G-BUG: Better Streets for Guildford

18th October 2021

#### **Comment on 20/P/02155 RE: Weyside Urban Village (Slyfield regeneration Programme)**

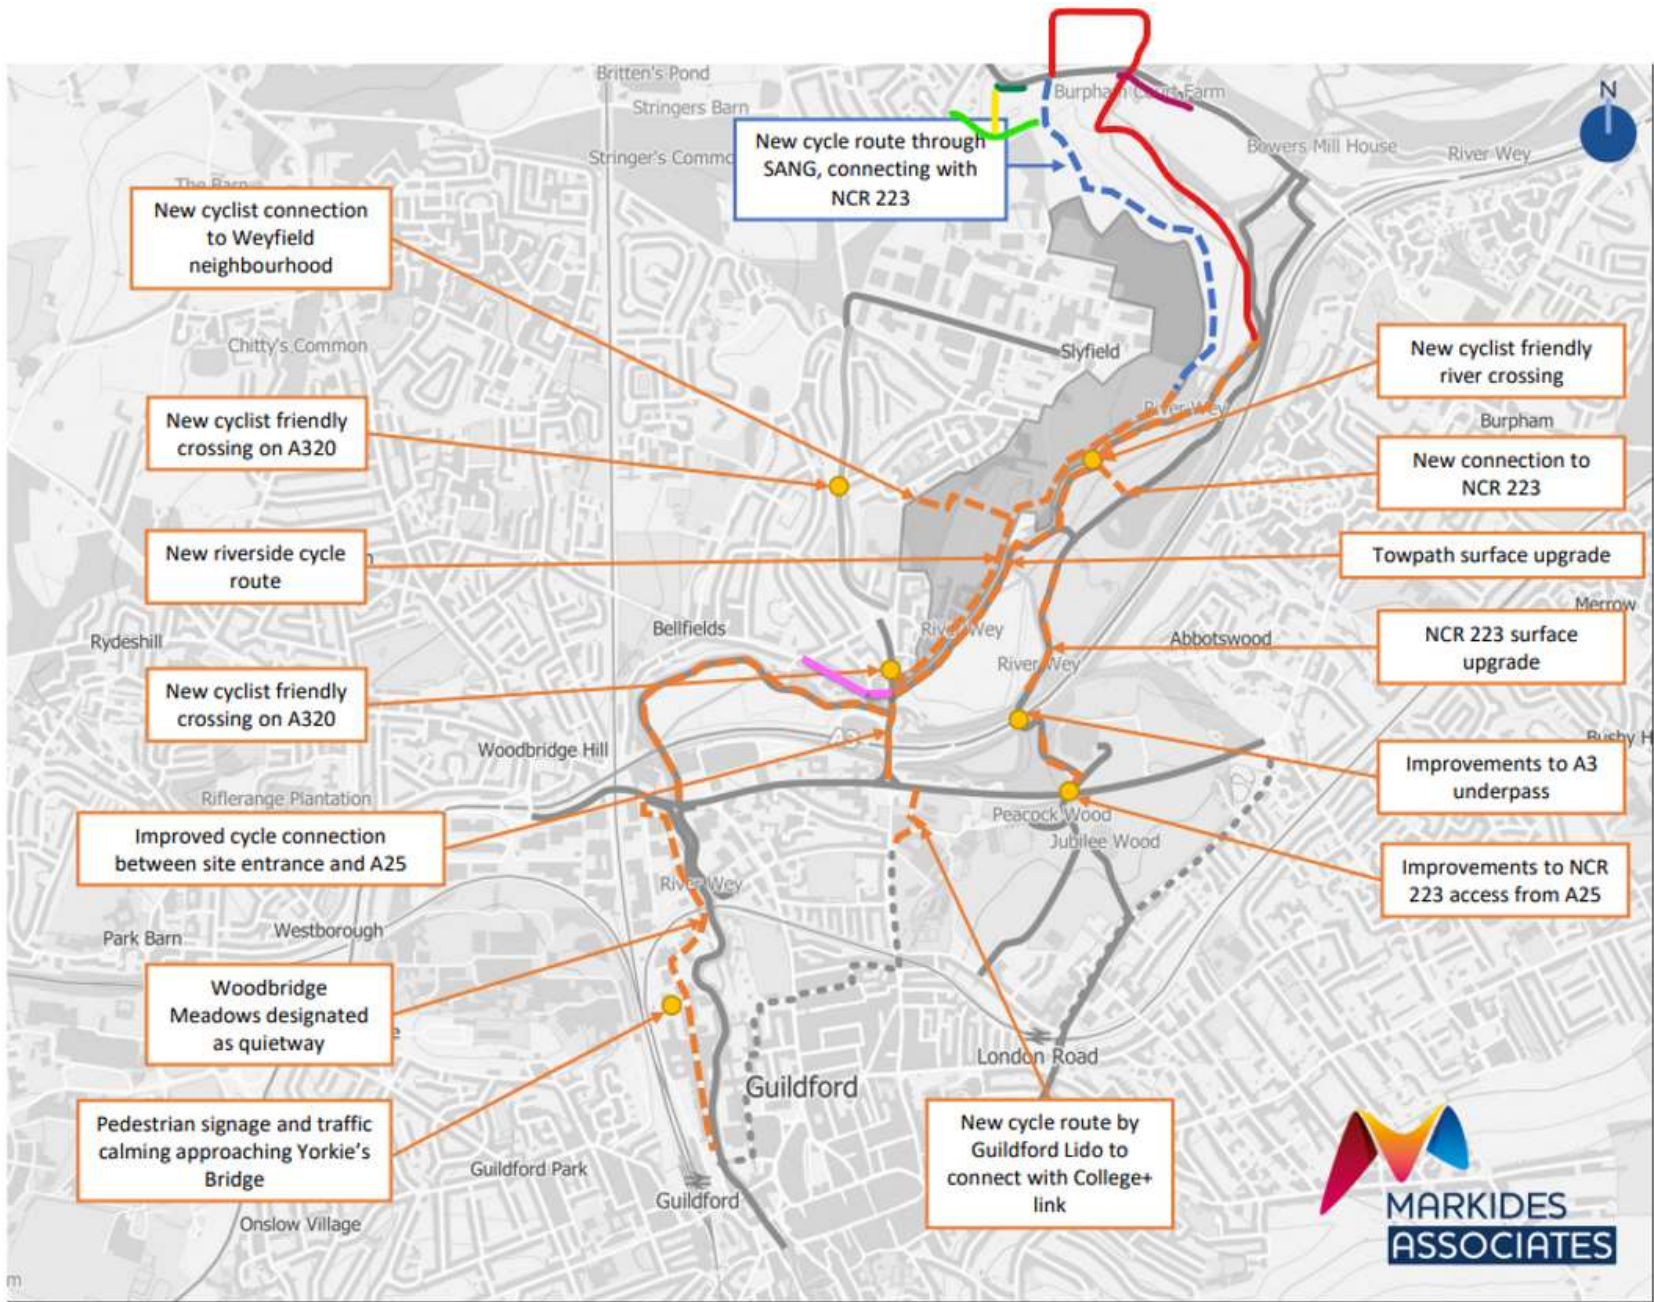
3. The new cycle route through the SANG needs to connect to Jacobs Well and Burpham otherwise it is essentially a dead end to a 40mph road. At the moment there are parts of the shared pedestrian/cycle path along Clay lane (to the north of the site) that are missing (in dark pink on the image below) or incredibly narrow, up an incline, round a bend and immediately adjacent to traffic i.e. dangerous (dark green on the image below). Has the team looked at upgrading footpath 438 (yellow on the image below) to a shared pedestrian/cycle path to avoid the dangerous bend?

5. No provision is made for cycle access to business and local amenities to the west of the A320 (Rowbargue Pub, Guildford Waterside Centre, Chemist, Doctor Surgery, Jarvis medical centre etc). Pedestrian and cycle access along Riverside should be improved (contraflow for cycles). A cycle/pedestrian crossing of the A320 at the end of Riverside should be created (light pink on diagram above)

6. Has the team investigated a route from the new cycle route through the SANG to the back of Jacobs Well village hall area (light green in the image above)?

7. The access through the SANG has substantially reduced from the last plans - it was a loop in the last set of plans (red in the image above), and gave access to the SANG north of clay lane, now it is one arm only. Can the loop be reinstated so people have more access to enjoy the countryside?

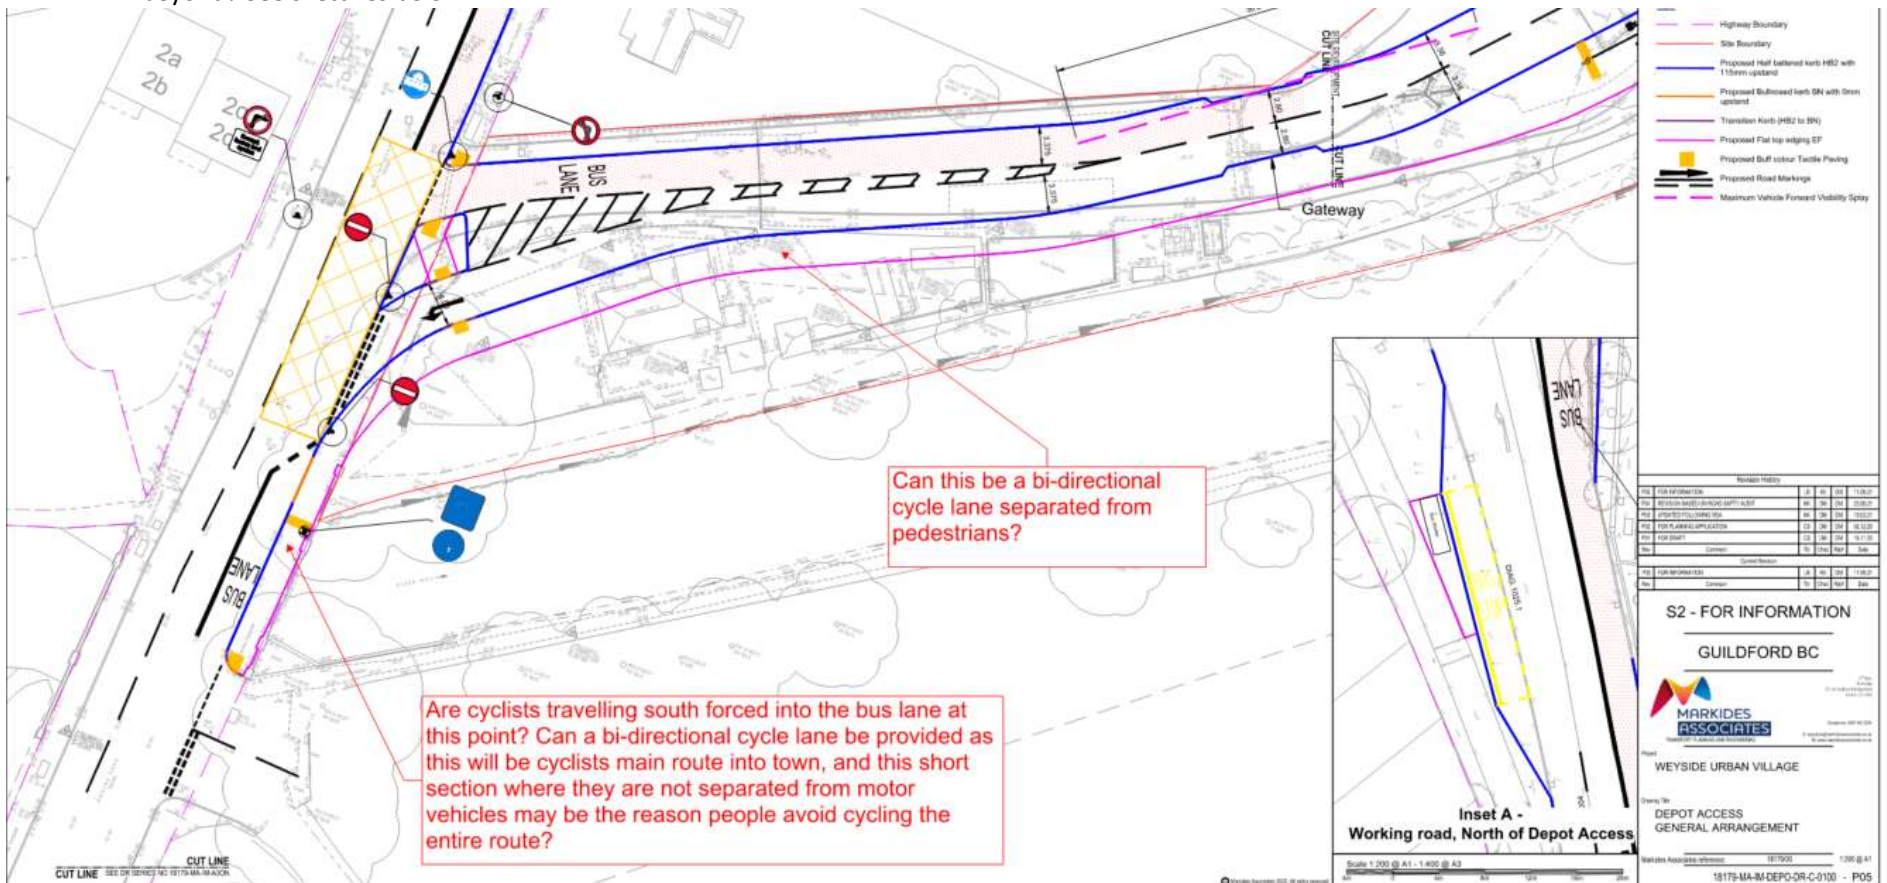
1. Provision should be made to cycle into Weyfield school as this road will now be busier with traffic to and from the site. Covered cycle parking should also be provided for all types of cycle.
2. 1.6.1 2 of LTN1/20 states that 'cyclists must be physically separated from pedestrians.' 'Perhaps with levels or a kerb'. Is there room for different levels or a kerb, rather than just different surfacing?

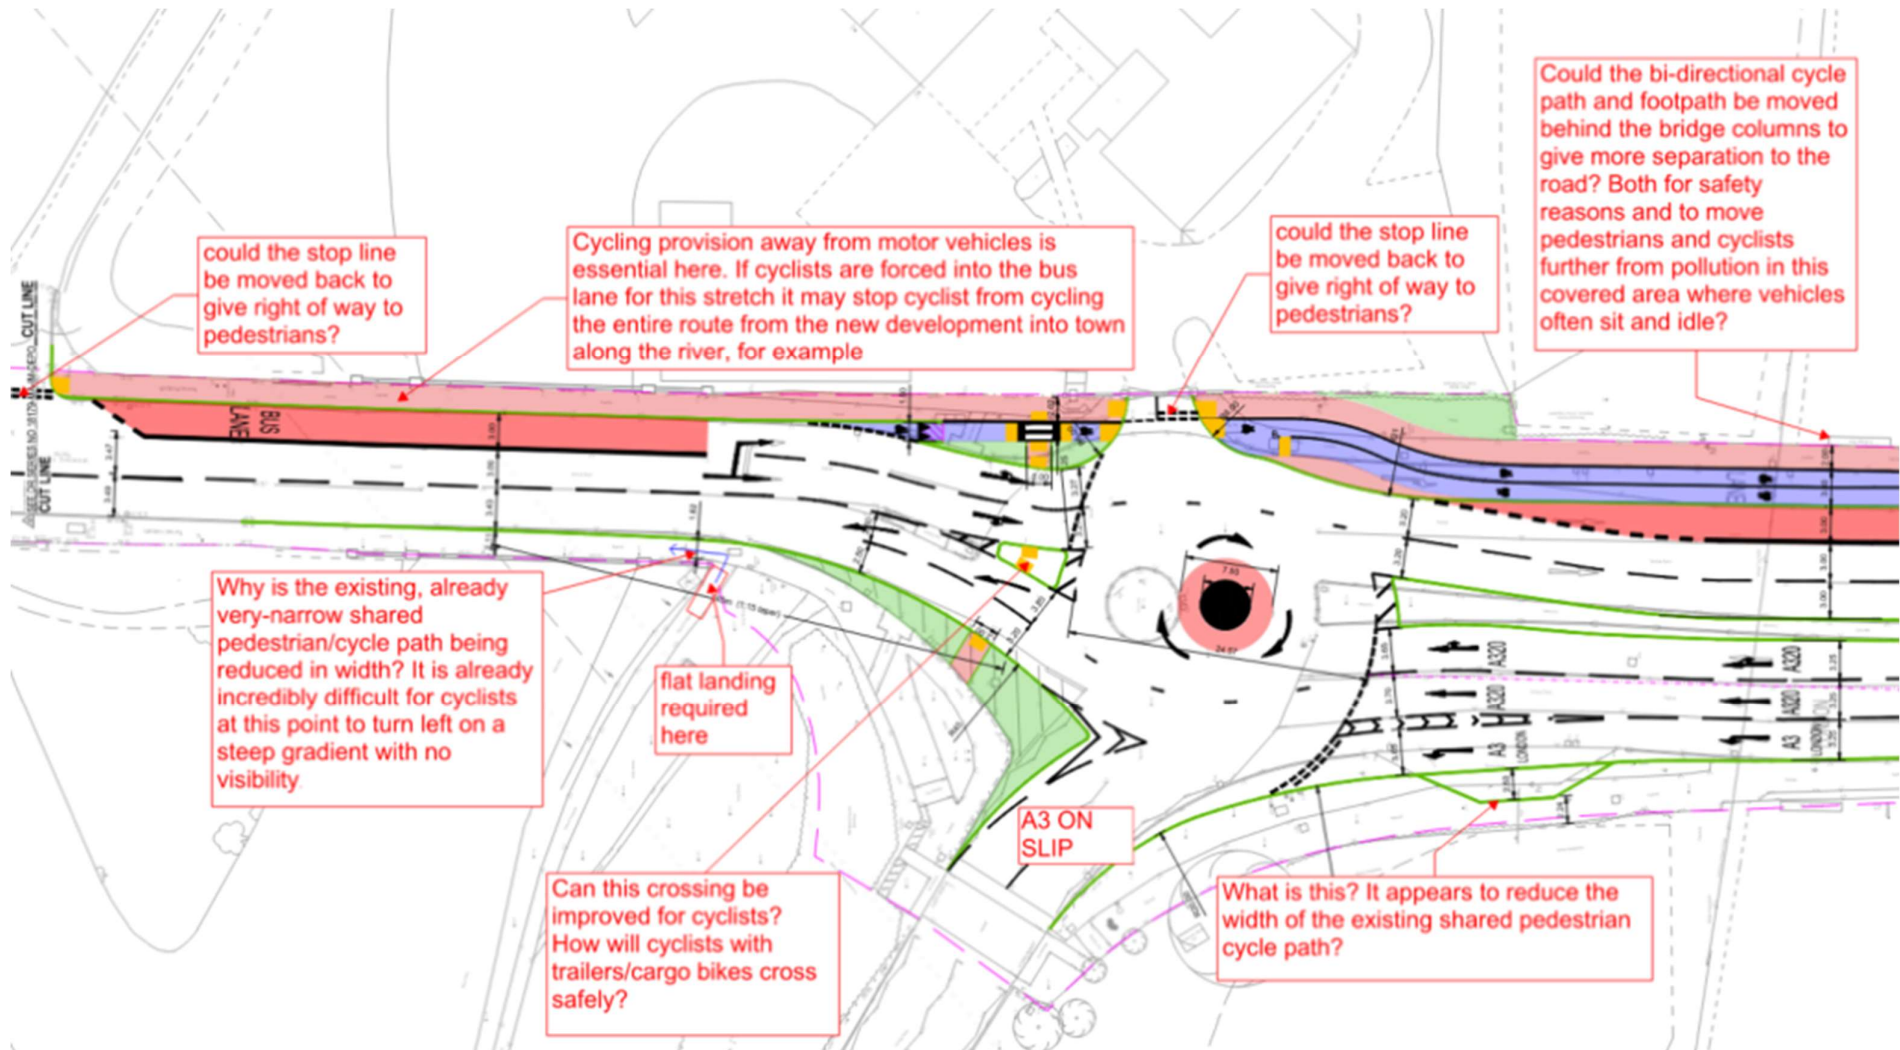
9. The northbound cycle lane stops just north of the A3 slip roundabout on the eastern side. Where are cyclists supposed to go to get to the development and beyond? See sketches below.

10. The current northbound cycle lane on the western side appears to have been made narrower at a particularly difficult location (see sketch above).
11. There is no provision for cycle traffic to cross the A320 at the exit from the site (Depot Road).
12. The stop line at the entrance to Stoke Mill House and at the adjacent junction should be moved back to give right of way to cyclists and pedestrians (see sketch above)

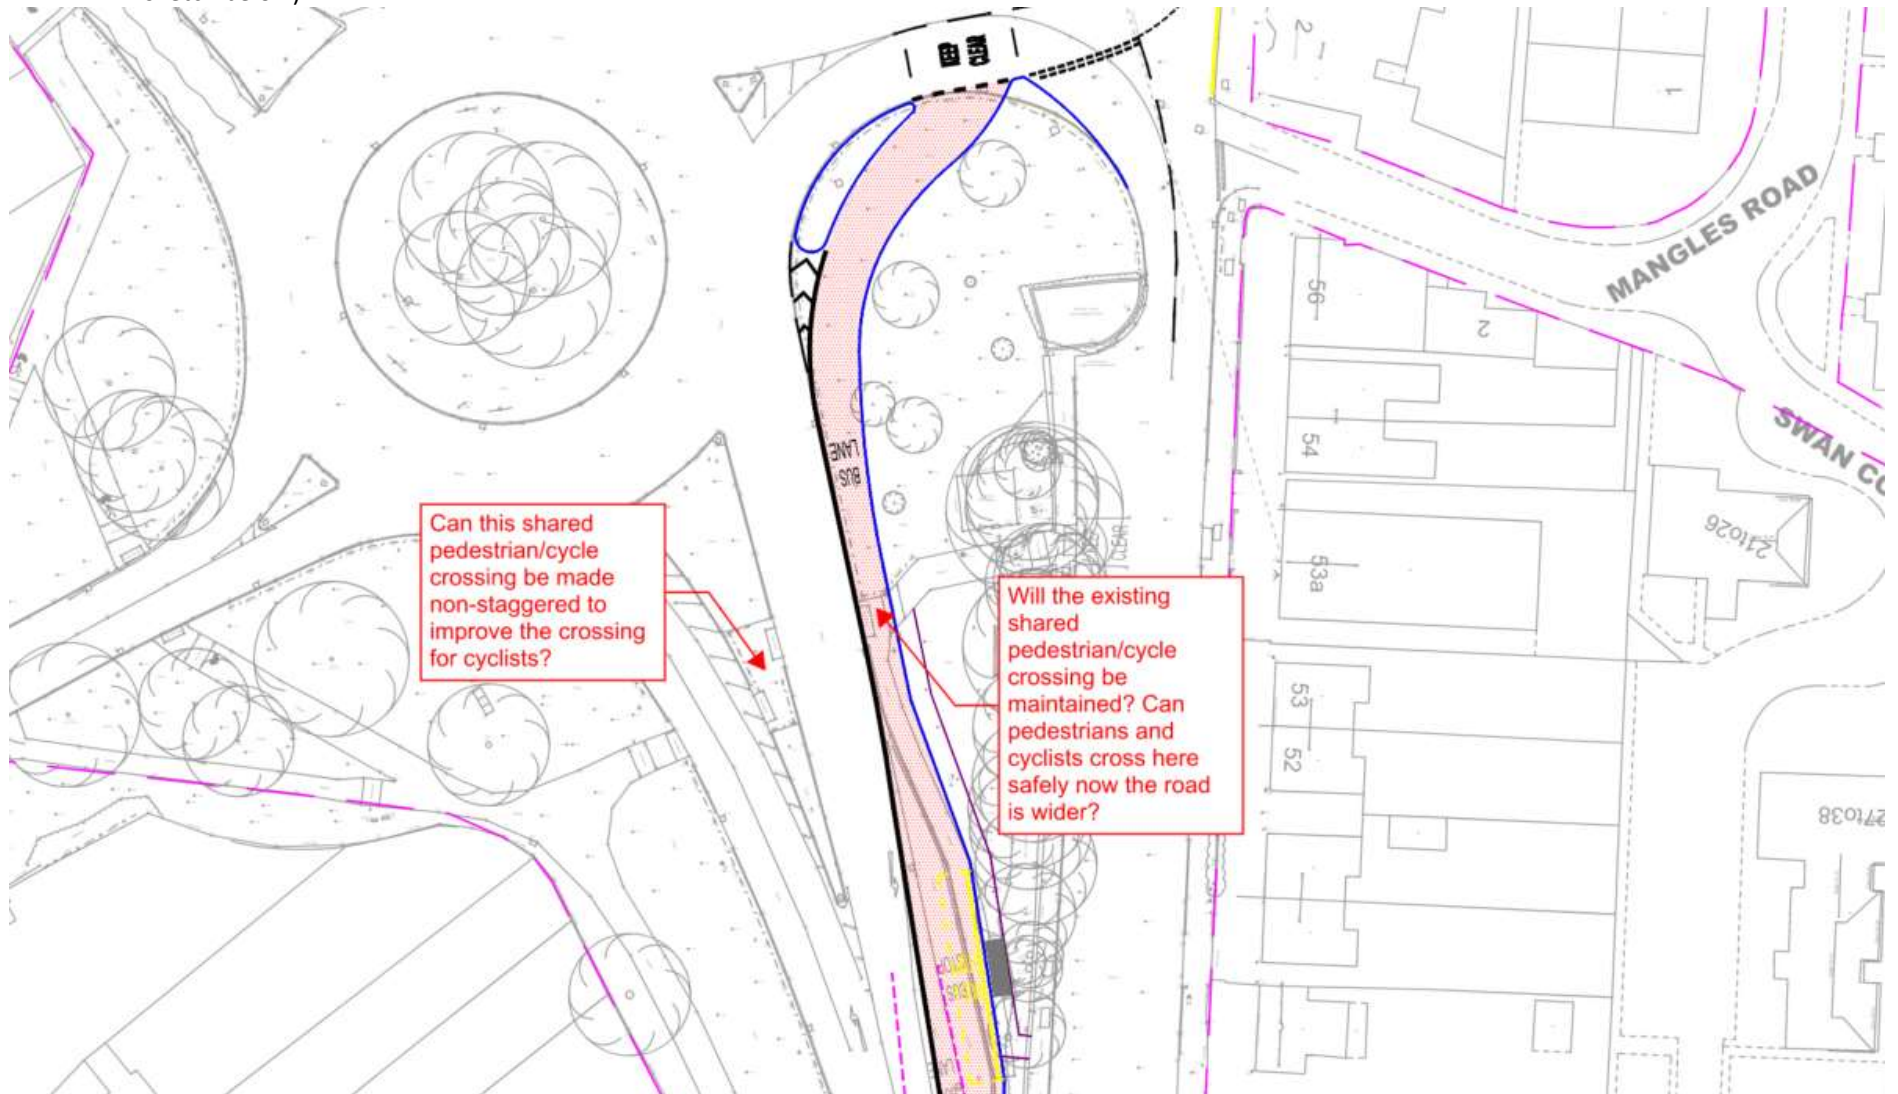
13. Could the bi-directional cycle path and footpath on the eastern side of the A320, as it runs beneath the A3, be moved behind the bridge columns to give more separation to the road (see sketch above)? The area would need digging out and a retaining wall installing. This would be beneficial for both safety reasons and to move pedestrians and cyclists further from pollution in this covered area where vehicles often sit and idle?
14. Will the existing shared pedestrian/cycle crossing along Woking road be maintained? Can pedestrians and cyclists cross here safely now the road is wider? (see sketch below)
